Metro Central Joint Development Assessment Panel Agenda

Meeting Date and Time: 27 November 2018, 9.00am
Meeting Number: MCJDAP/321
Meeting Venue: Town of Bassendean
48 Old Perth Road
Bassendean

- 8.1** Property Location: Lot 75 (No. 72) Walter Road East (cnr Marion Street), Eden Hill
- Development Description: Convenience Store Providing for the Sale of Fuel and Convenience Goods (Vibe)
- Applicant: Planning Solutions
- Owner: K. & W. Sales & Distribution Pty Ltd
- Responsible Authority: Town of Bassendean
- DAP File No: DAP/18/01473

SITE PLAN 1:200

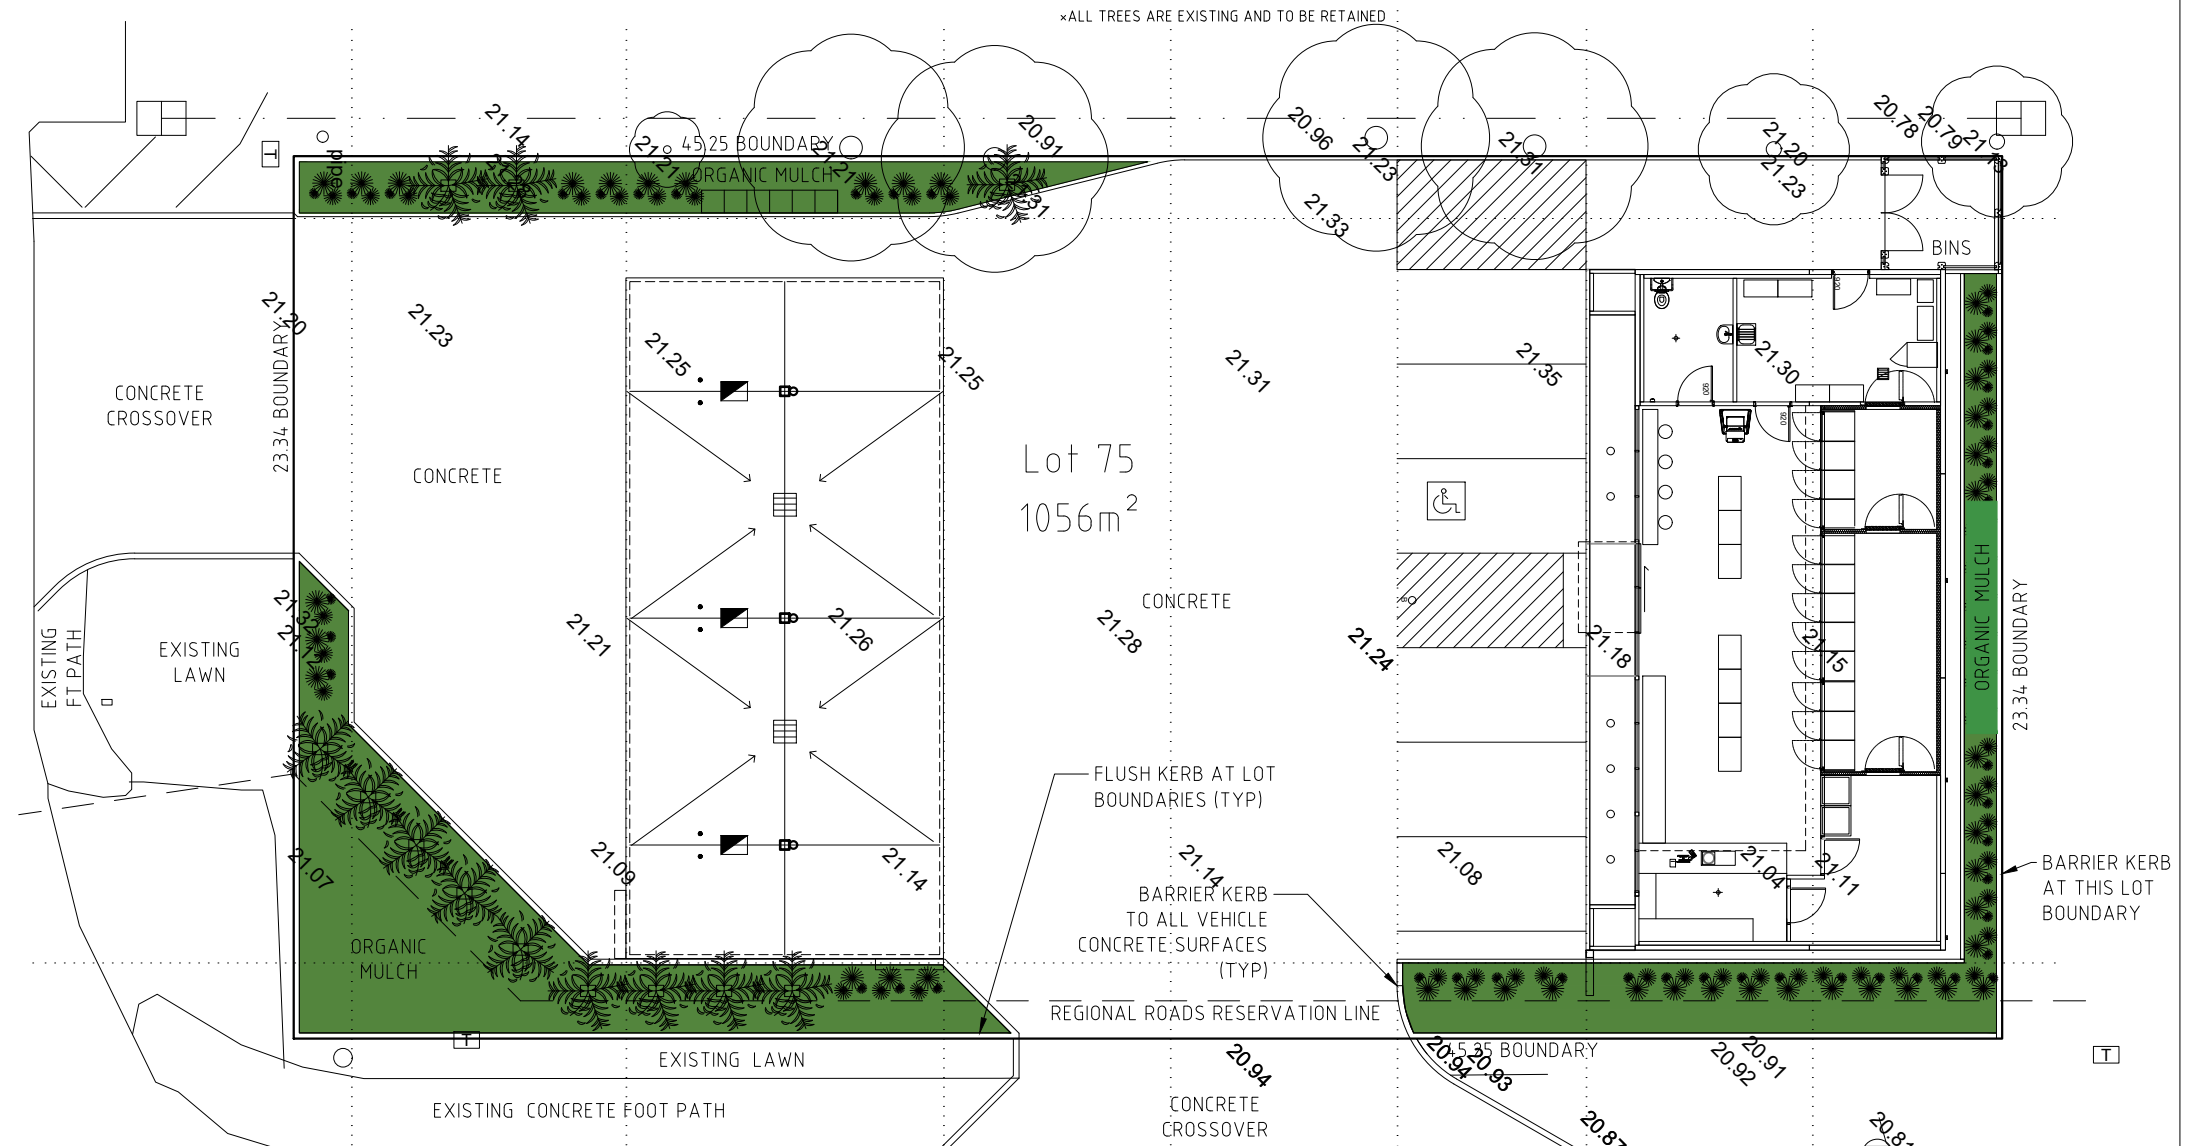
13. The width of landscaping along the Walter Road East frontage of the proposed development being less than that specified by Town of Bassendean Local Planning Policy No. 7 – Local Shopping Design Guidelines;

14. The proposed building setbacks to the Walter Road East frontage of the development site are considered to be unacceptable, having regard to the unsatisfactory urban design outcome that results from the blank building façade facing this street. As proposed, the compatibility of the development with its setting in terms of its orientation and appearance is not acceptable, contrary to clause 67(m) of the Planning and Development (Local Planning Schemes) Regulations 2015;

Car Parking – Dimension of Bays - Customers	2.6m minimum bay width prescribed by AS2890.1 for convenience store customer bays.	2.5m bay width proposed.	No Customer car bays for convenience store are under width. See further comment after table.
Bowser Bay – Dimensions	2.9m minimum bay width prescribed by AS2890.1 (i.e. 2.9 x 2 = 5.8m width required between obstructions associated with bowzers).	5.3m width provided between obstructions associated with bowzers.	No See further comment after table.
Commercial Vehicle – Dimensions of Service Bay	3.5m minimum bay width prescribed by AS2890.2.	3.0m service bay width proposed.	No See further comment after table.
Service Vehicle Access – Petrol Tankers (Within the development site)	AS 2890.2 states that design should be prepared to accommodate standard 19m long petrol tankers. (Vehicle Class – Articulated Vehicle)	Design based upon a non-standard 15m tanker length with no justification provided for such design basis. (Unknown Vehicle Class which is not referenced in relevant Australian Standard)	No Site cannot be serviced by a standard petrol tanker. See further comment after table.

Vehicle Movement Through Site	Safe and coordinated vehicle movement through site.	The design allows vehicles to enter the site from either Marion St or Walter Rd East and to traverse the site in opposing directions.	No Having regard to site constraints, traffic movement through the site should be limited to one way only. See further comment after table.

Figure 4: Fuel tanker turn path analysis

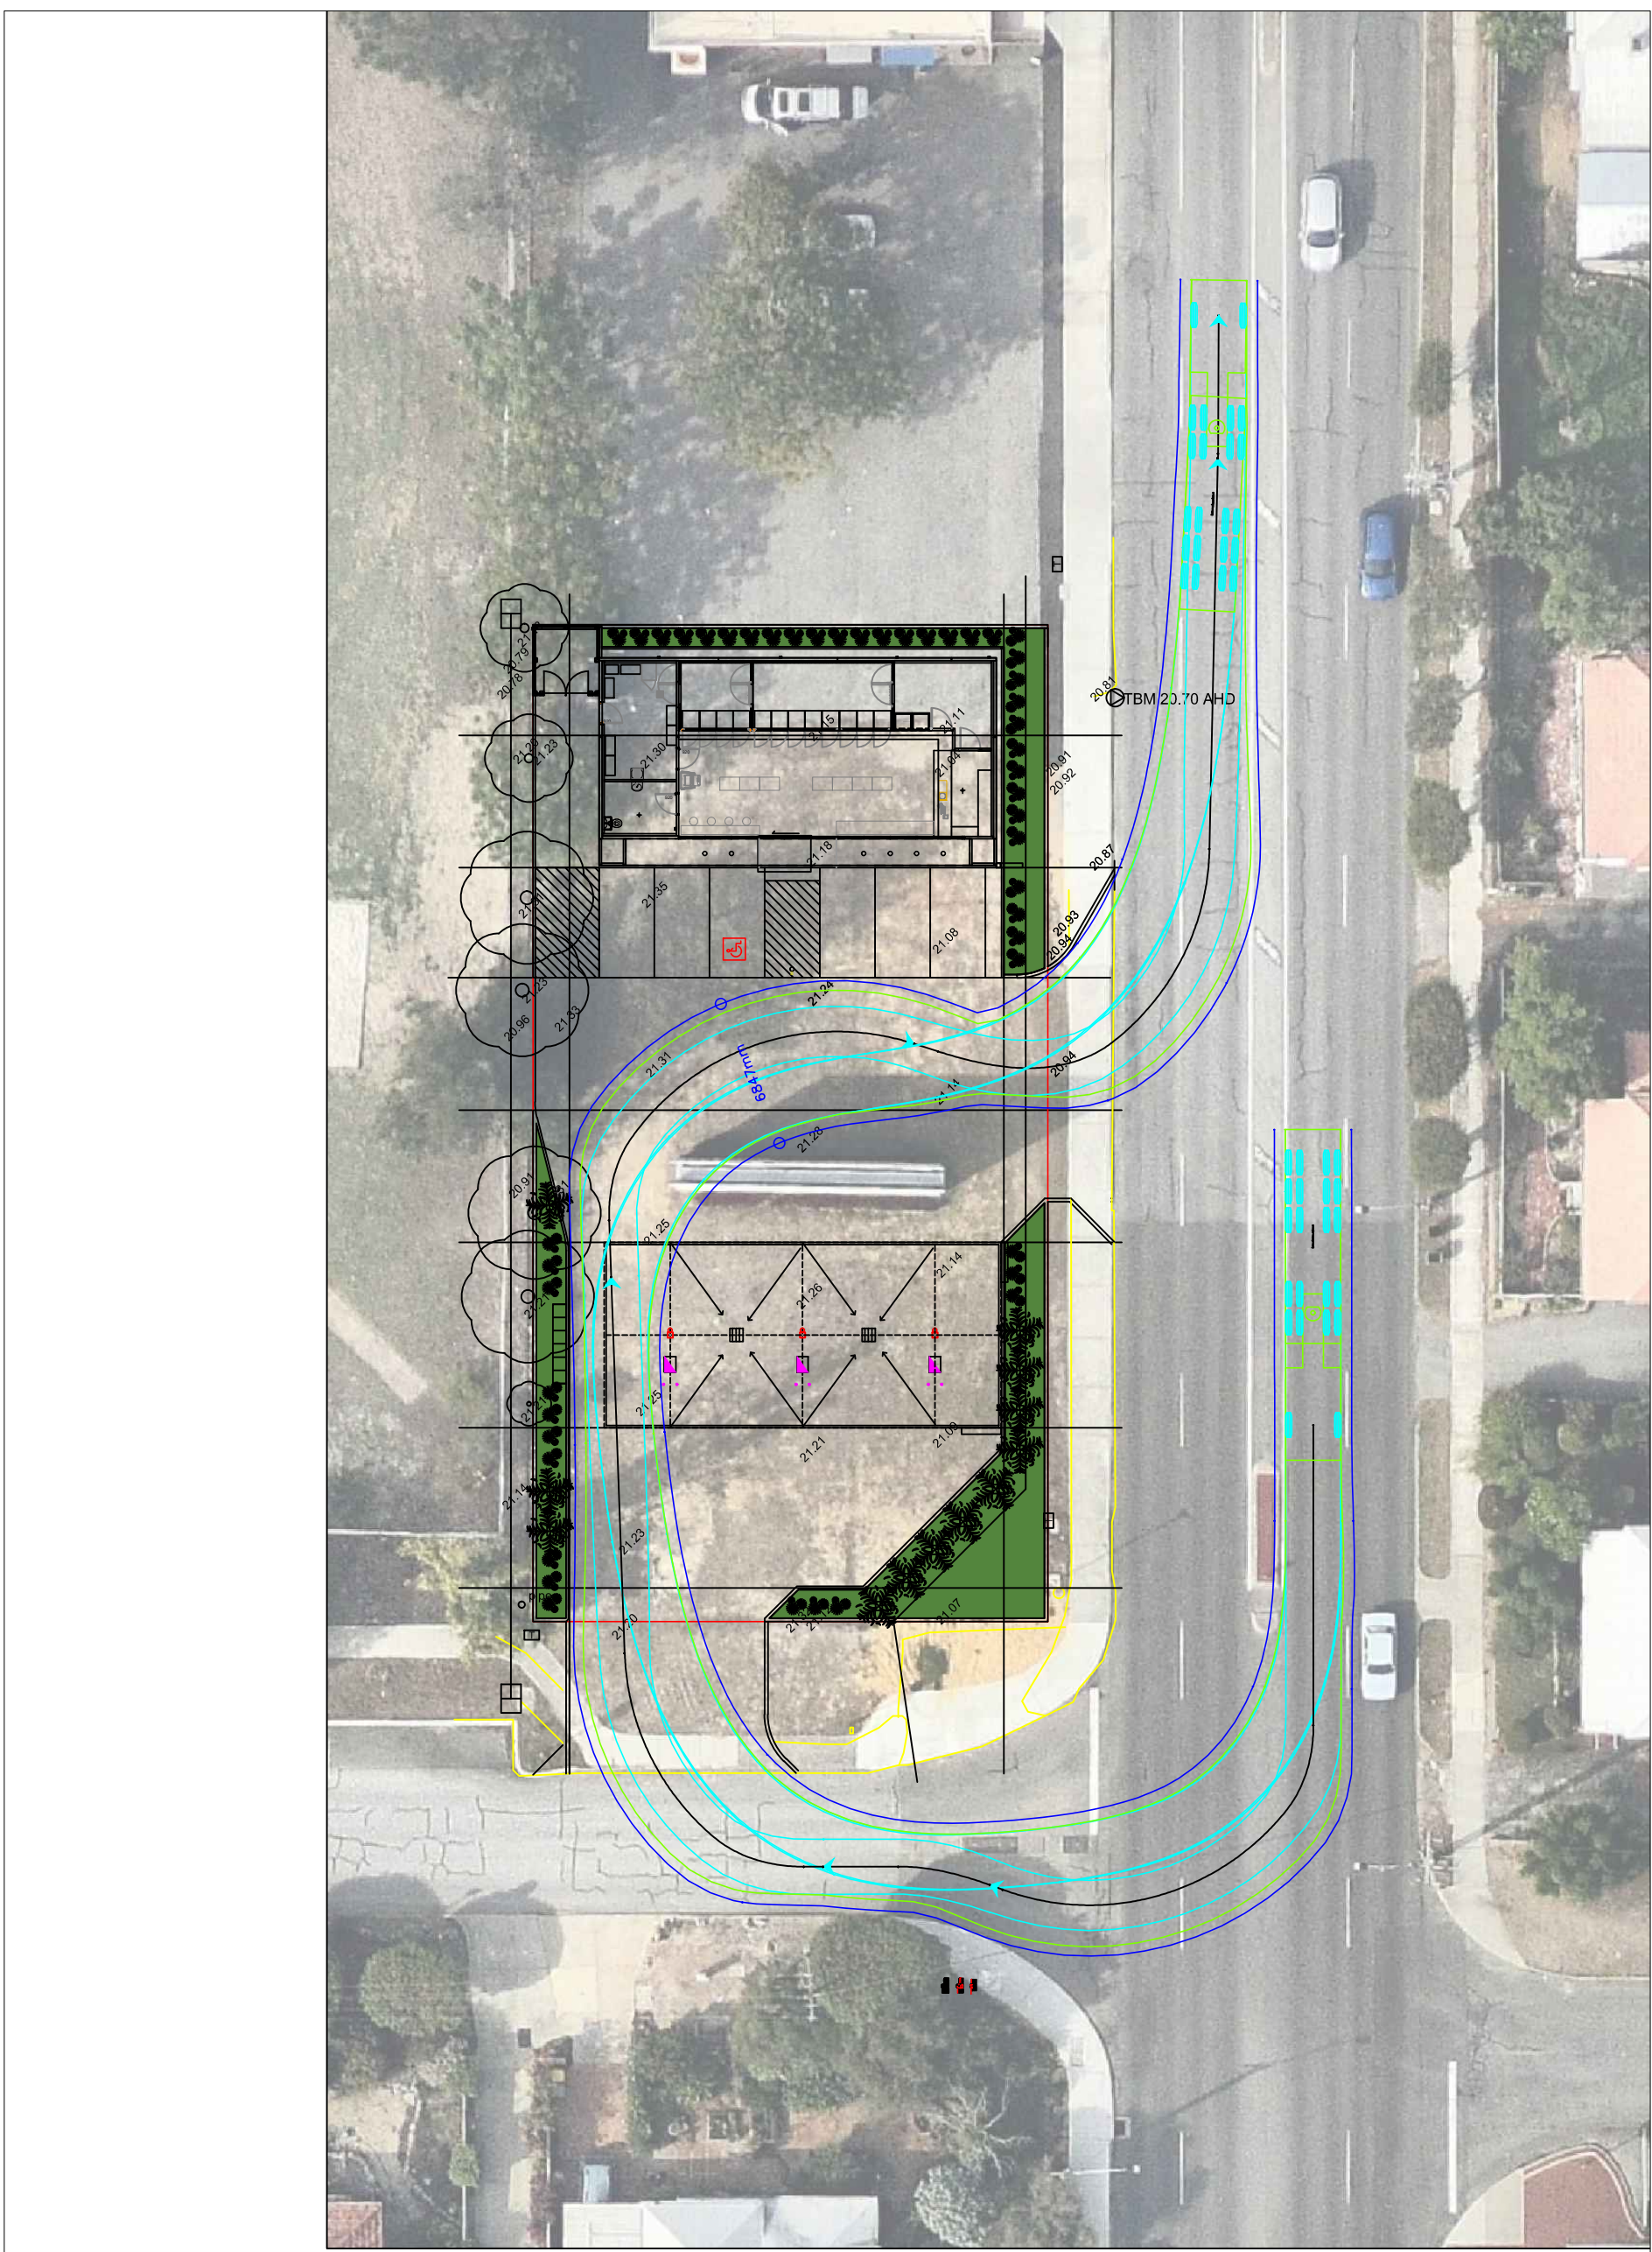
The applicant has been asked to provide information / justification regarding the 15m length tanker referred to in application documentation, however no such information / justification has been provided and in the absence of this the facility should be designed to accommodate the industry standard service vehicle (i.e. 19m long tanker) as specified by Australian Standard AS2890.2 – Parking Facilities – Part 2: Off-street commercial vehicle facilities.

When approaching the development along Walter Road East (from the west), petrol tankers are unable to remain lane correct (i.e. they must use the entirety of the road), when turning into Marion Street. They must then use the entirety of the Marion Street road pavement up to the point where they enter the development site (and when entering the development site they must also utilise the entire width of the crossover on the Marion St frontage of the development site).

If a petrol tanker is arriving at the Marion St / Walter Rd East intersection at the same time that vehicles are attempting to exit Marion St onto Walter Rd East in a westerly direction, the petrol tanker must wait on Walter Rd East and allow vehicles on Marion Street to clear completely in order that it can make its (non-lane correct) approach to the entrance of the petrol station. However, while paused on Walter Rd East, a petrol tanker would be blocking the line of sight for vehicles wanting to exit onto Walter Rd East. The line of sight for such vehicles would be restricted beneath Approach Site Distance (ASD) requirements and below Safe Intersection Sight Distance Requirements (SISD) as specified within the Austroads Guide to Road Design.

The inability of a petrol tanker to remain lane correct when approaching the site along Marion St; the restriction on sight lines that would result if a petrol tanker needed to pause on Walter Rd East to allow traffic to clear Marion St and the inability of a standard 19m long petrol tanker to service the development are each unsatisfactory from a traffic safety perspective.

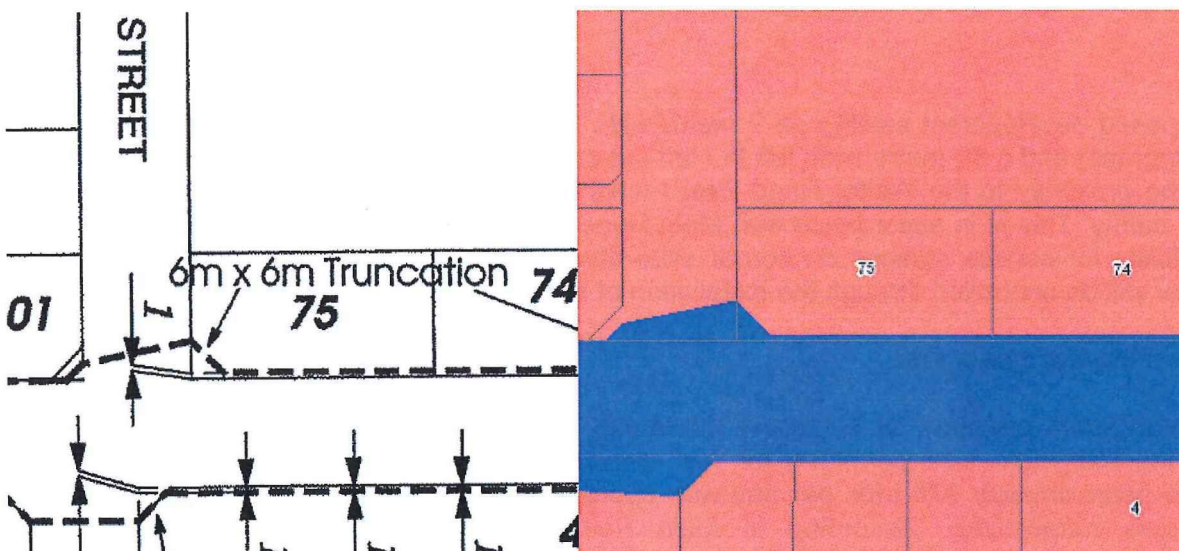
- It is recommended that the submitted swept path analysis plans be verified / checked to the satisfaction of the Town's Technical Services Directorate, particularly as the site is limited to 1056m² in area. 15.0 metre long semi-trailers / fuel tankers are required to make sharp internal turning movements within the site which may not be practically possible due to the location of the proposed crossover to Walter Road East;

- The Department supports the provision of a median treatment within the Walter Road East reservation in order to limit turning movements from the site to left in / left out only;
